In the Drawings:

Remarks

Objections to the Drawings

Fig. 1

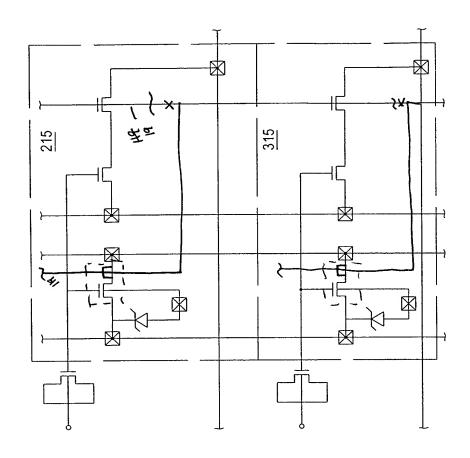
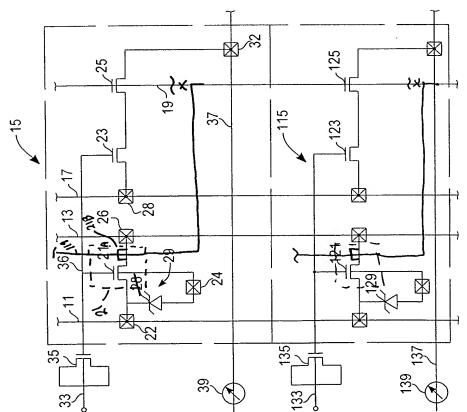
Fig. 1 has been amended to remove duplicate label "28" from the cathode of diode 29. Contact 28 remains. Word line 19 has been redrawn and word line 119 has been added for consistency with Figs. 2 & 4.

Element 28 of Fig. 1: The designation of the anode of diode 29 as element "28" has been removed. Element "28" remains a contact of transistor 23.

Fig._4

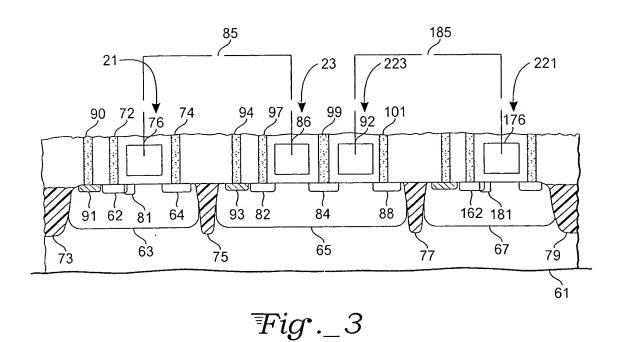
Fig. 4 has been amended to re-designate unidentified line "201" to "103." Line '33" has been relabeled "36" for consistency with Figs. 1 & 2.

Line 201 of Fig. 4: Element 201 has been redesignated "actuation line 103". Element number 101 is present in Fig. 3. Element 201 is present in Fig. 8. The reference in the specification to "shared line 101" has been deleted.

Fig._8

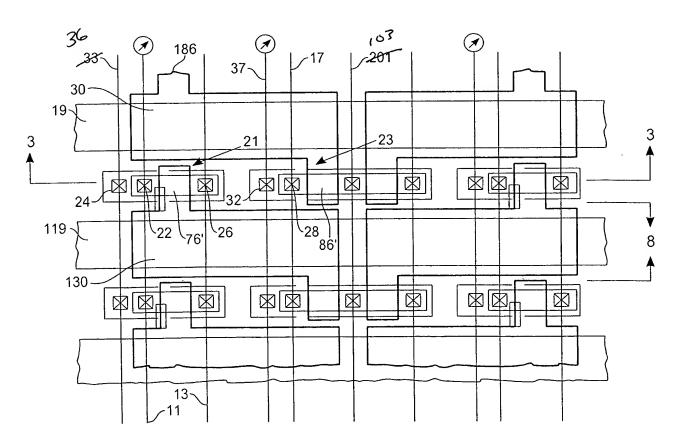
Fig. 8 has been amended to re-designate element (Nwell) "119" as element "140." Word line 119 is present in Figs. 2 & 3.

Nwell 119 of Fig. 8: Fig. 8 has been revised. Element 119 has been re-designated "103;" the label "10+" has been changed to "P+" to correct a scrivener's error.
